**SUBJECT:** NuScale Power, LLC Response to NRC Request for Additional Information No. 397 (eRAI No. 9238) on the NuScale Design Certification Application

## Response to Request for Additional Information Docket No. 52-048

**NRC Question No.:** 11.05-2

Clarification of Type E variables for Control room HVAC

Figure 7.1-2: Post-Accident Monitoring General Arrangement Drawing

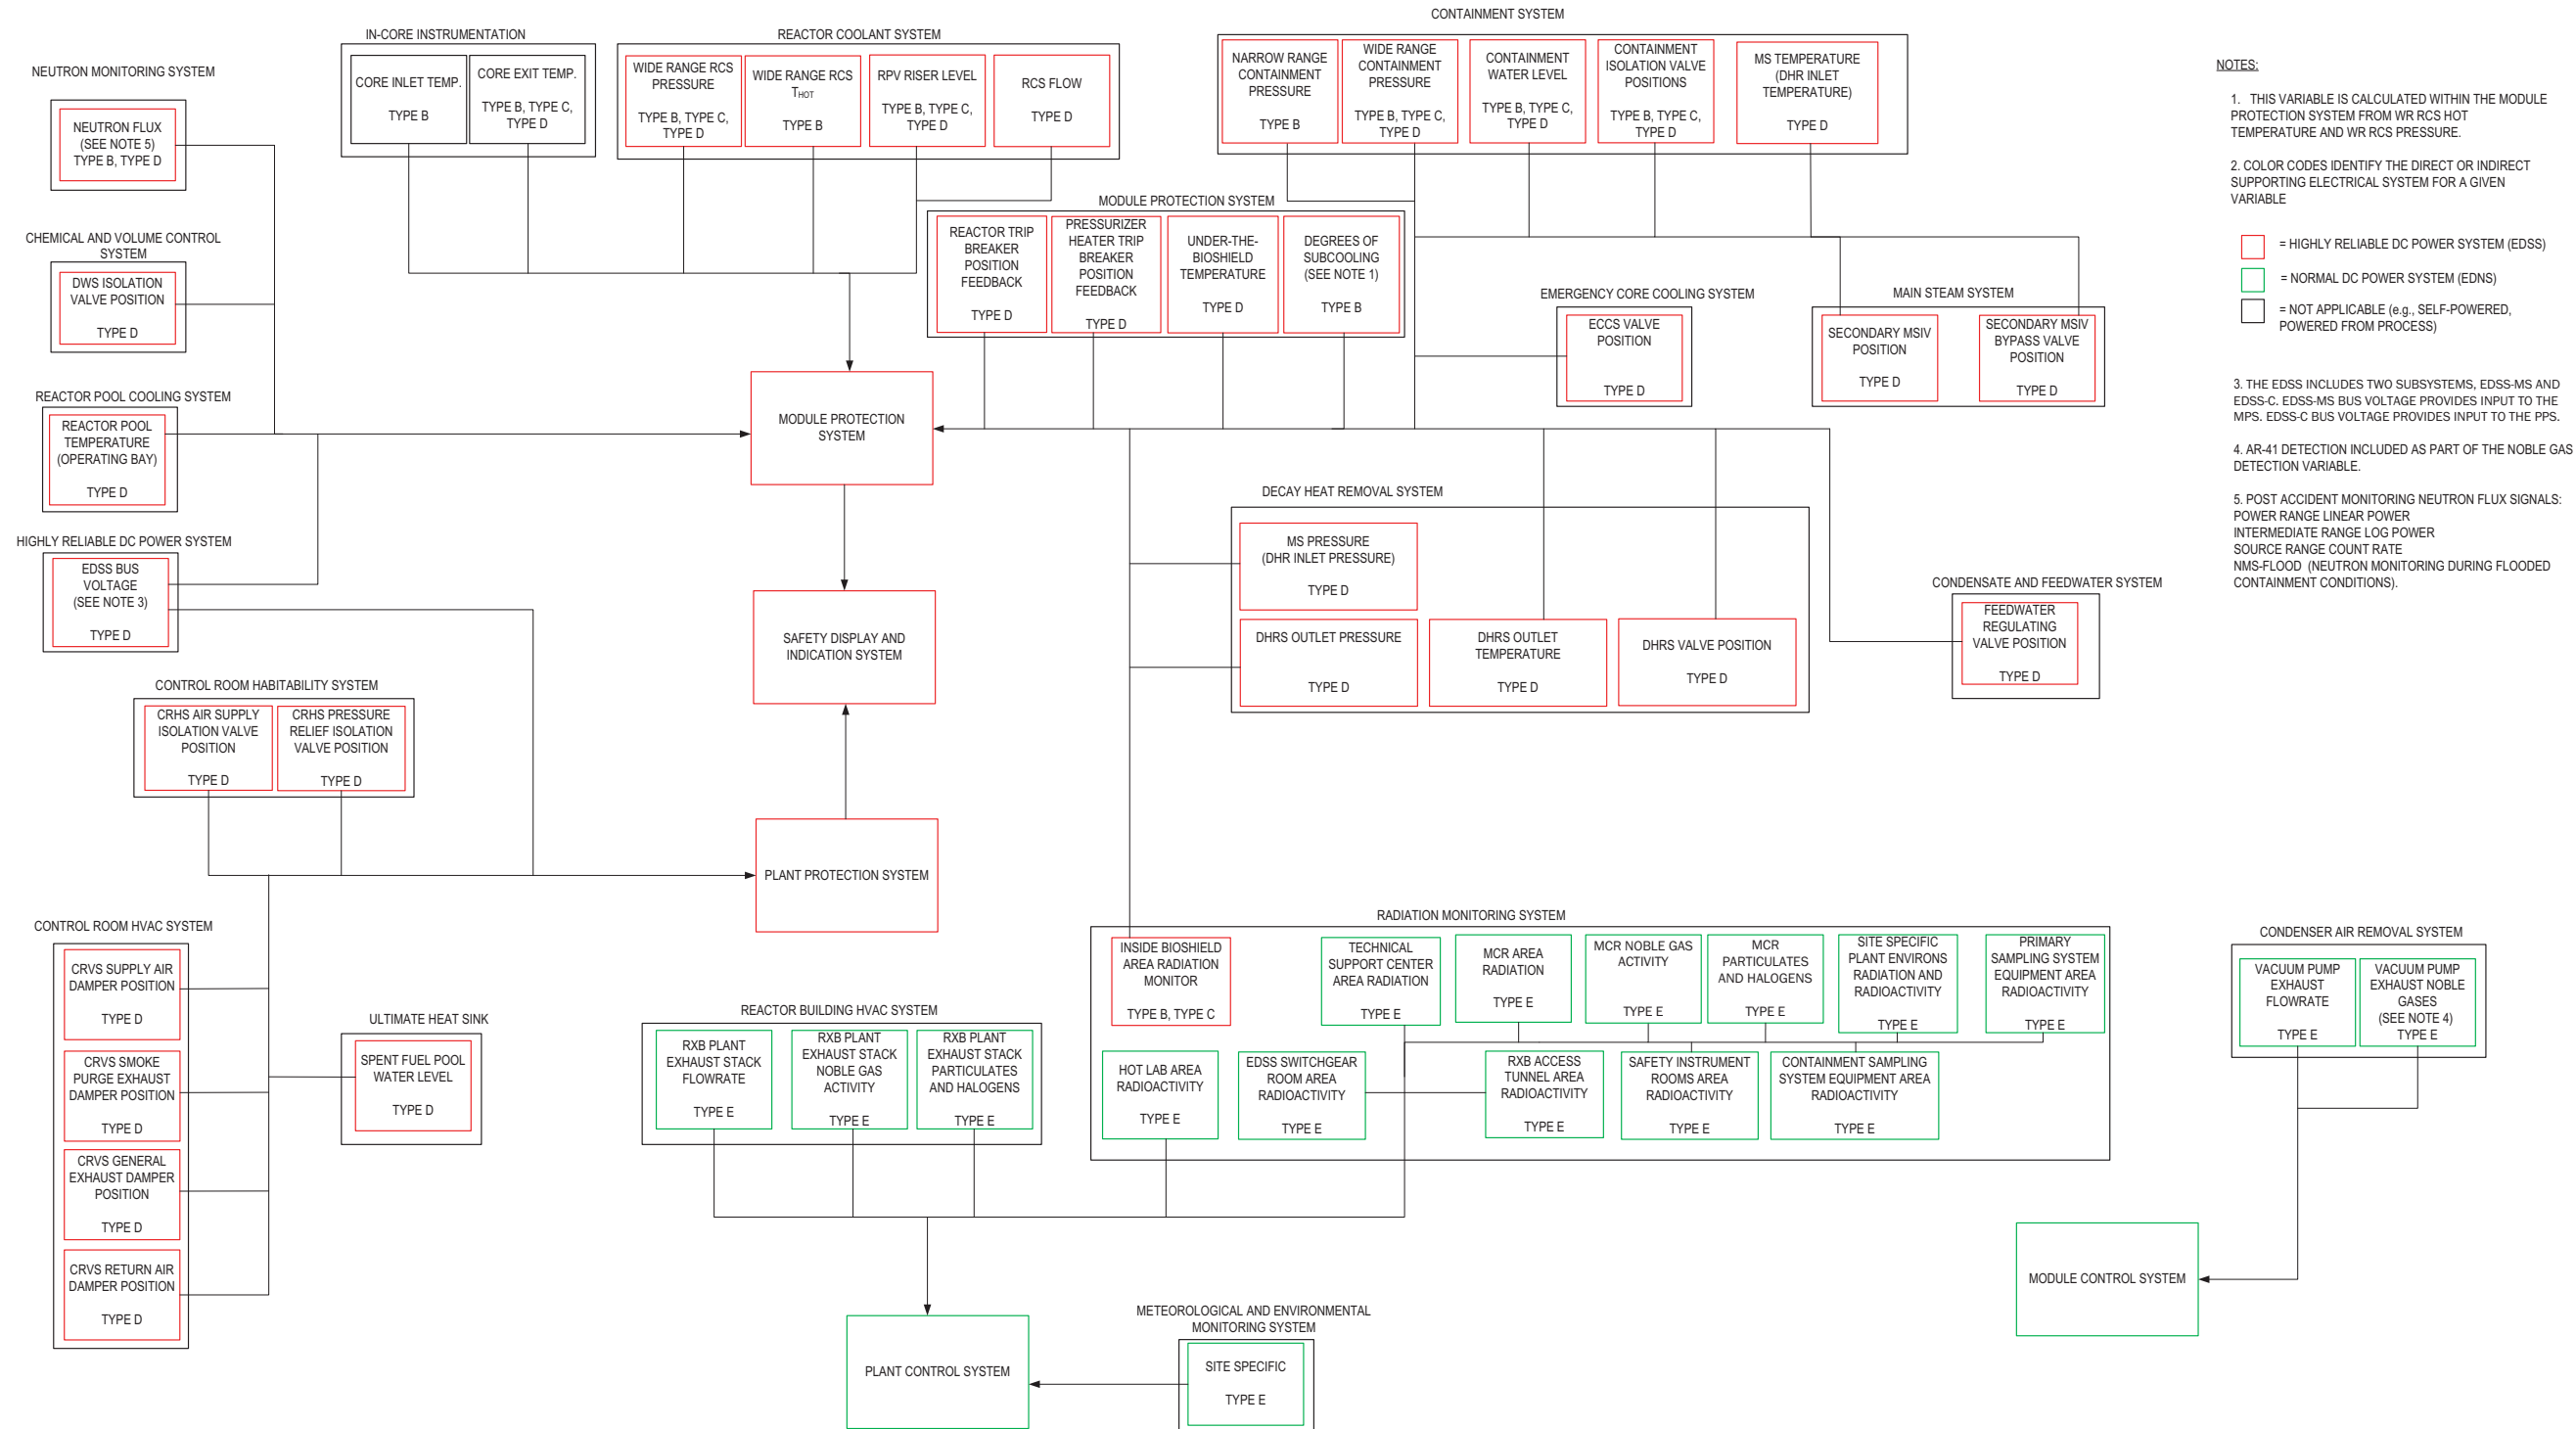
1. The staff requests that the applicant provide a monitor that characterizes the control room radiation and radioactivity levels, ensuring it monitors beta and gamma radiations, or requests the applicant justify why the currently existing monitor in the design would meet the guidance specified in RG 1.97 which endorses the IEEE 497- 2002's Type E variable standard.
2. The staff requests that the applicant provide changes to DCA section 7.1.1.2.2 to correct the stated definition of the Type E variables, which omits "the control room and," to be in conformity with IEEE 497-2002.

filters is isolated from the MCR atmosphere after the control room habitability system actuates, an additional airborne radiation monitor is added inside the MCR to monitor both beta and gamma radiation in the atmosphere within the control room envelope. This new airborne radiation monitor provides two new Type E variables: MCR noble gas activity and MCR particulates and halogens, consistent with the guidance of IEEE 497-2002. FSAR Figure 7.1-2, Table 7.1-7, Table 12.3-10 and Table 12.3-11 have been revised to include this additional airborne radiation monitor and these additional Type E variables.

FSAR Section 7.1.1.2.2, Table 7.1-7, Table 12.3-10, Table 12.3-11, and Figure 7.1-2 have been revised as described in the response above and as shown in the markup provided in this response.
